California Regional Water Quality Control Board  
Santa Ana Region

ITEM: 8

SUBJECT: Waste Discharge Requirements for Regent Ramona Creek, LLC, Ramona Creek Development Project, Northeastern Corner of Florida Avenue and Warren Road, City of Hemet, Riverside County – Order No. R8-2015-0032

**EXHIBIT 2 – Order No. R8-2015-0032**  
 Ramona Creek Development Project, Hemet

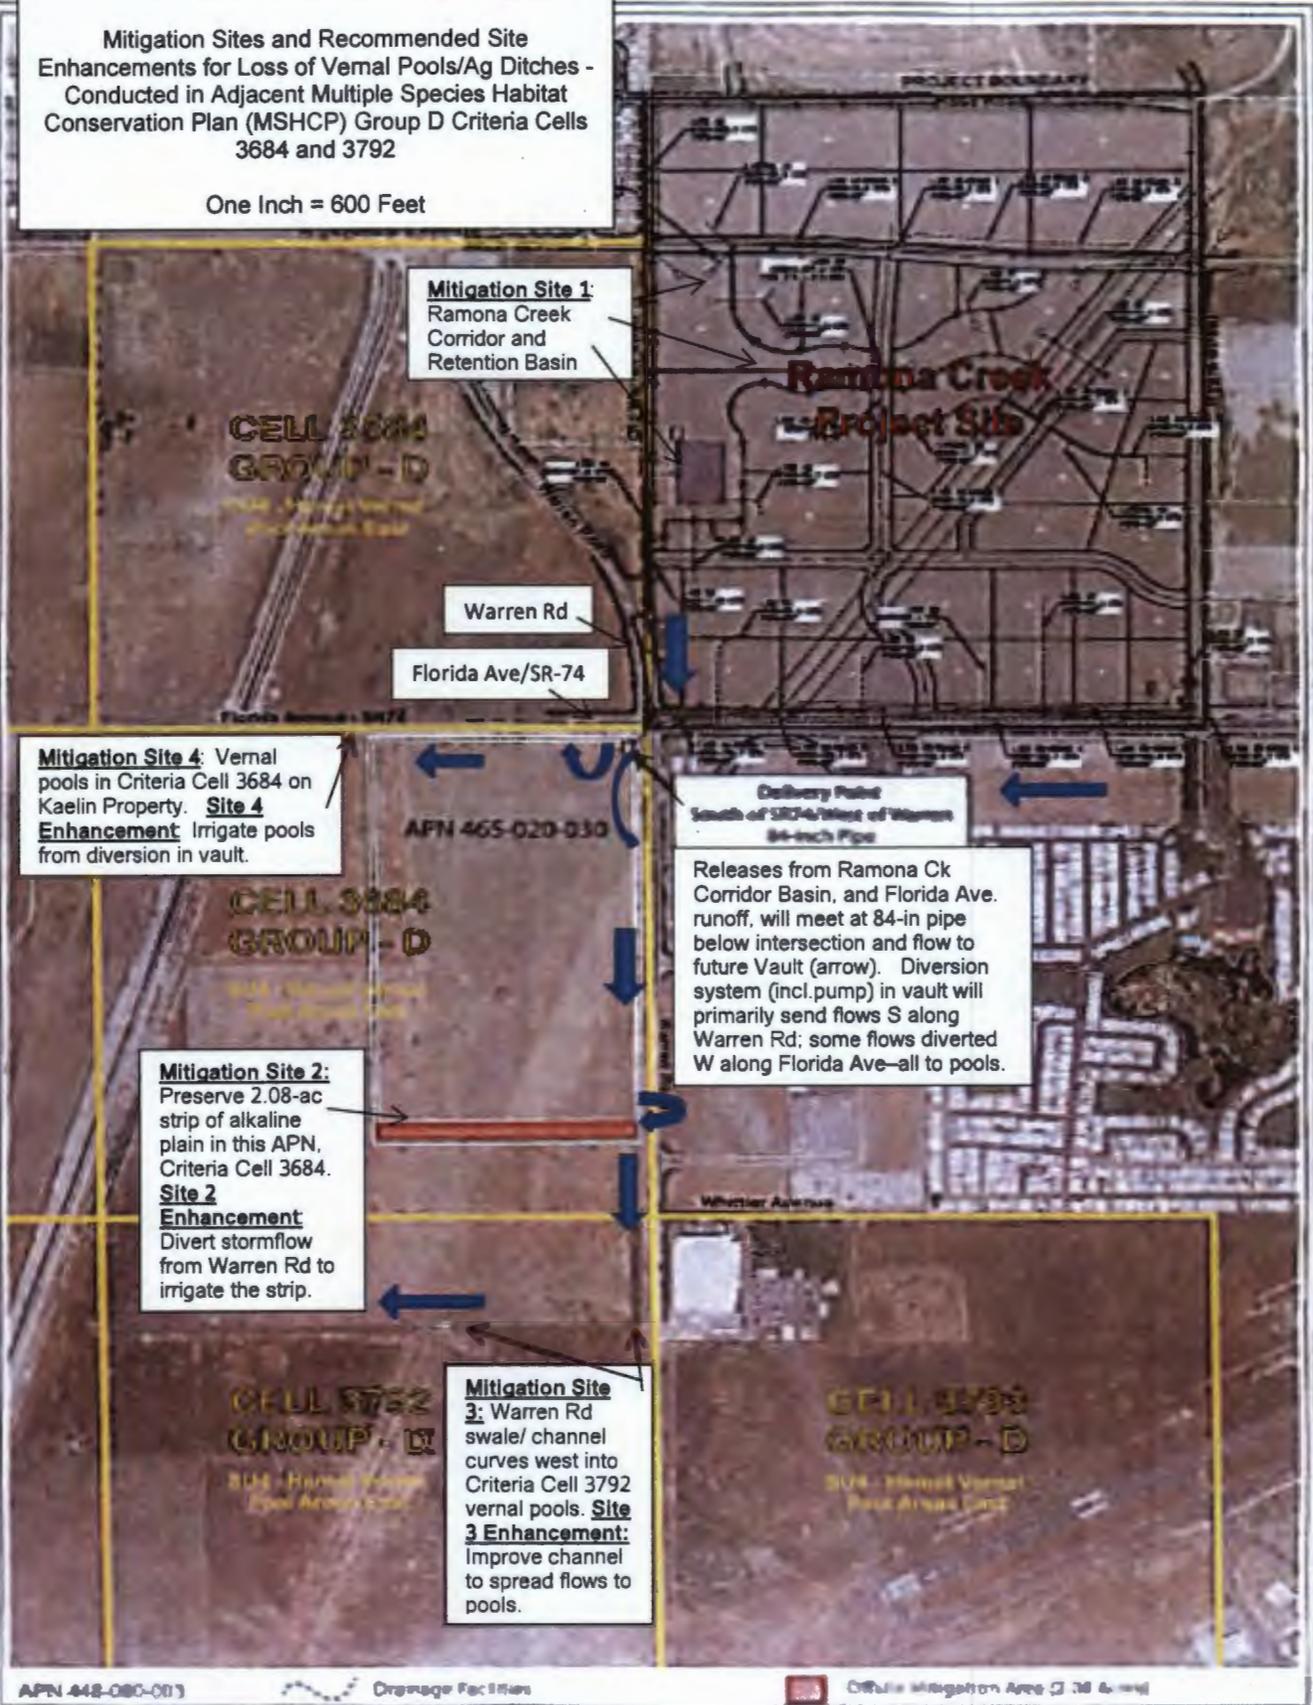
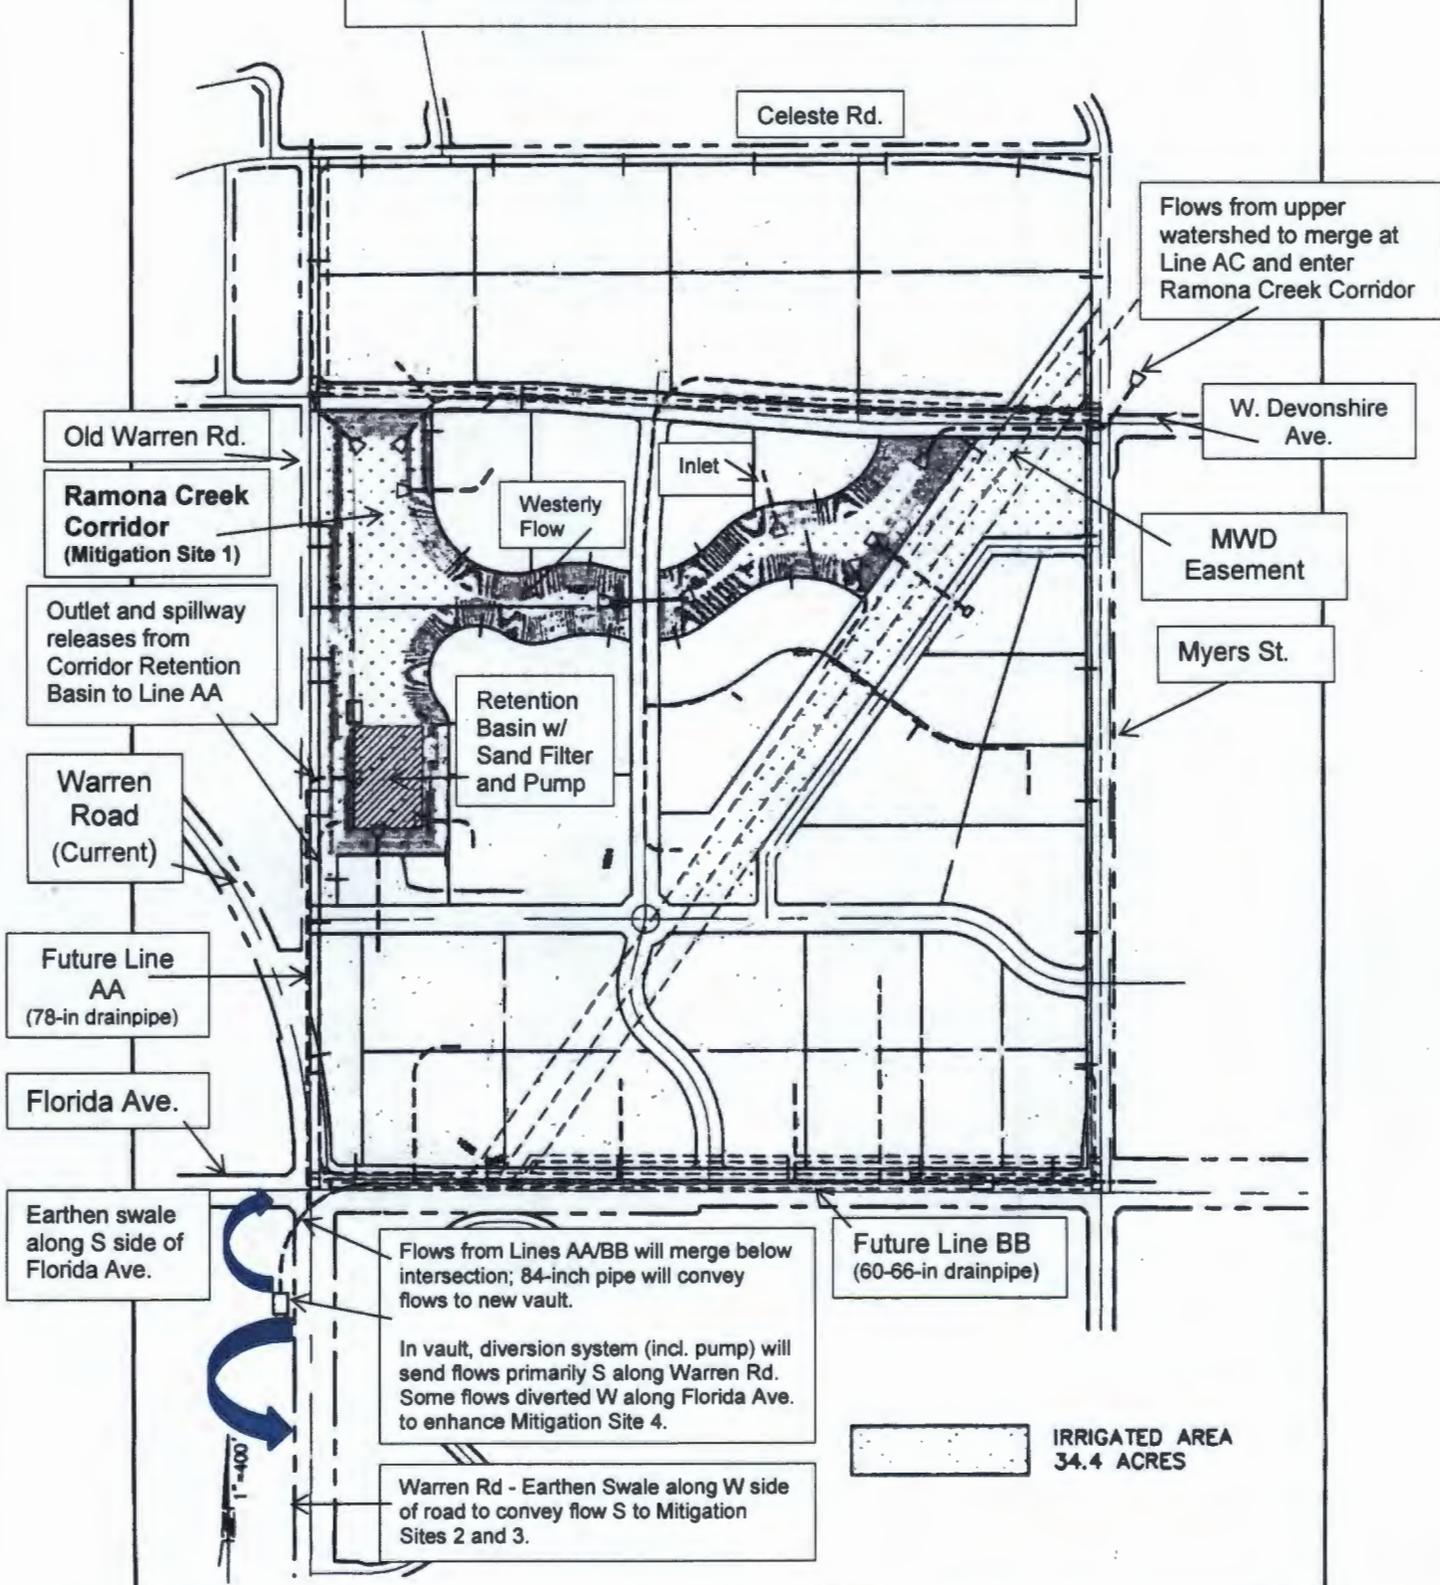
2. The 2.08 acre mitigation site (within MSHCP Criteria Cell 3684; Exhibit 2, Mitigation Site 2) does not contain vernal pools with functioning hydrology at the present time. However, it is believed that a portion of this mitigation site has characteristics that would allow the formation of a pool(s) provided that there is adequate hydration. City staff indicates that providing flows to this area is anticipated as part of the design of the Master Drainage Plan. However, once again, the precise nature and timing of that Plan are not known at the present time.

1. Spreading of flows exiting the earthen swale/trapezoidal channel (located along the west side of Warren Road) into the vernal pool complex in the northern part of MSHCP Criteria Cell 3792 (Site 3 Enhancement), via grading or another suitable method.

2. Diversion of flows from the earthen swale along the west side of Warren Road to the area upslope of, or directly into, the 2.08 acre mitigation area in APN-465-020-030, Criteria Cell 3684 (Site 2 Enhancement), via a suitable method.

3. Installation of a diversion system, as part of the planned construction of a vault below the southwest corner of Florida Avenue and Warren Road (Site 4 Enhancement). The diversion system would be designed to convey intermittently water that is stored in or flowing through the vault to the west, along the south side of Florida Avenue to the vernal pool complex in the northwestern portion of MSHCP Criteria Cell 3684 (the "Kaelin property"; Mitigation Site 4). Minor grading may be necessary to eliminate ponding along Florida Avenue and to enable these flows to reach the immediately adjacent vernal pool complex.

Accordingly, tentative Order No. R8-2015-0032 requires that the Discharger demonstrate, in advance of grading at the site, that use of the RCA Ramona Creek Project Trust Fund will be sufficient for, and limited to, expenditures necessary to implement the following vernal pool site mitigation enhancement projects (Exhibit 2 for all):

To assure that each of these mitigation measure enhancements is properly designed and engineered to fulfill its purpose, the tentative Order requires field demonstration of their efficacy to the satisfaction of Regional Board staff. Corrective action is required if the efficacy of the enhancements is not demonstrated.
